## **Questions For Beta**

# Deeper understanding of traffic study assumptions & impacts

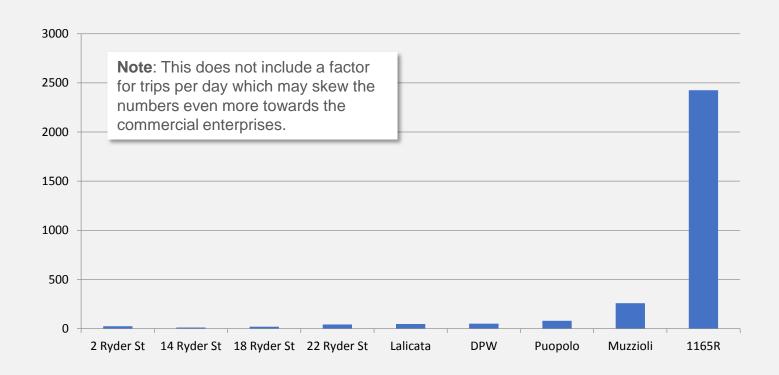
**Access Points**: Are two access points necessary for a development of this size? The developers said they have built complexes larger than this with one curb cut, so why are two being proposed?

Mass Ave Access: The intersection of Forest Street and Mass Ave is one of the most dangerous in Arlington and the state. How much safer would this be if the entry/exit point was moved from 1165 Mass Ave which is 80 feet from that intersection to 1125 Mass Ave which is 450ft from that same intersection?
